**City of Bellevue  
Development Services Department  
Land Use Staff Report**

**Proposal Name:** Wendle

**Proposal Description:** The applicant is requesting a Critical Areas Land Use Permit to reduce an existing 50-foot (ft) steep slope top-of-slope buffer to a 20-ft buffer to allow for the expansion of an existing single-family residence. The proposal includes a mitigation plan to provide 350 square feet (SF) of new native plantings in the top-of-slope buffer. .

**File Number:** 19-105723-LO

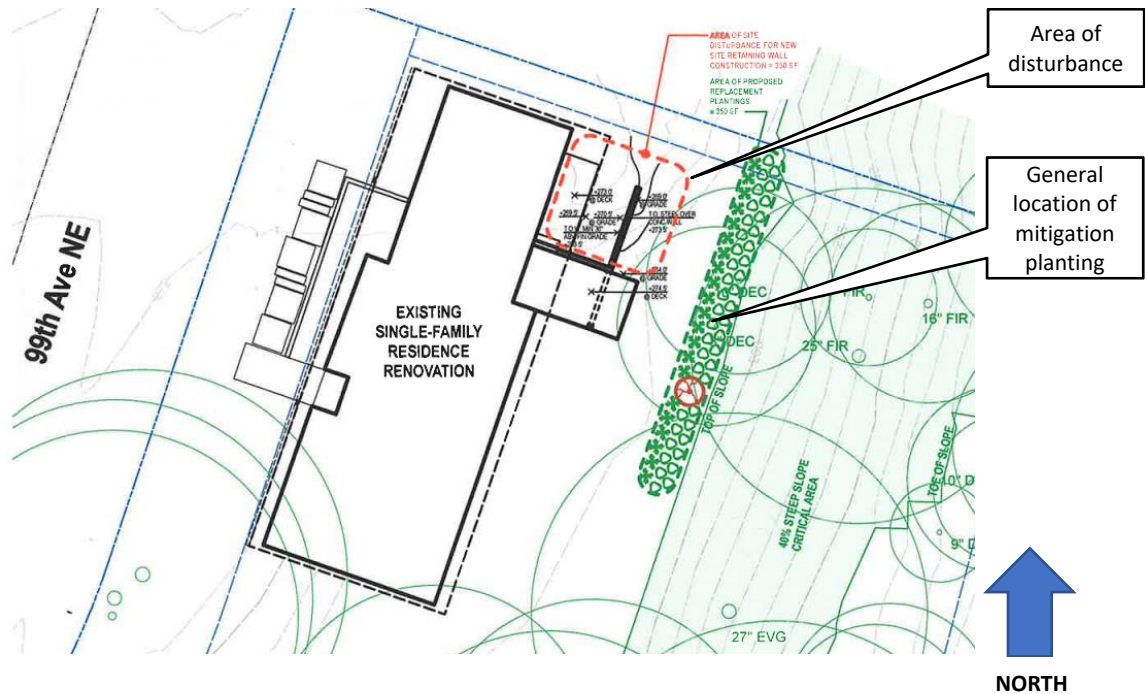
**Finding:** Meets requirement. The proposed upper floor expansion is along the existing building line parallel to the edge of the steep slope critical area. Due to the location and geometry of the existing residence and the functions of the interior spaces, the proposed interior addition, site retaining wall and exterior decks encroach further into the standard 50-ft. critical area buffer. Per the Geotechnical Report, the proposed structural expansions do not encroach into the critical area buffer reduction from 50-ft. to 20-ft.
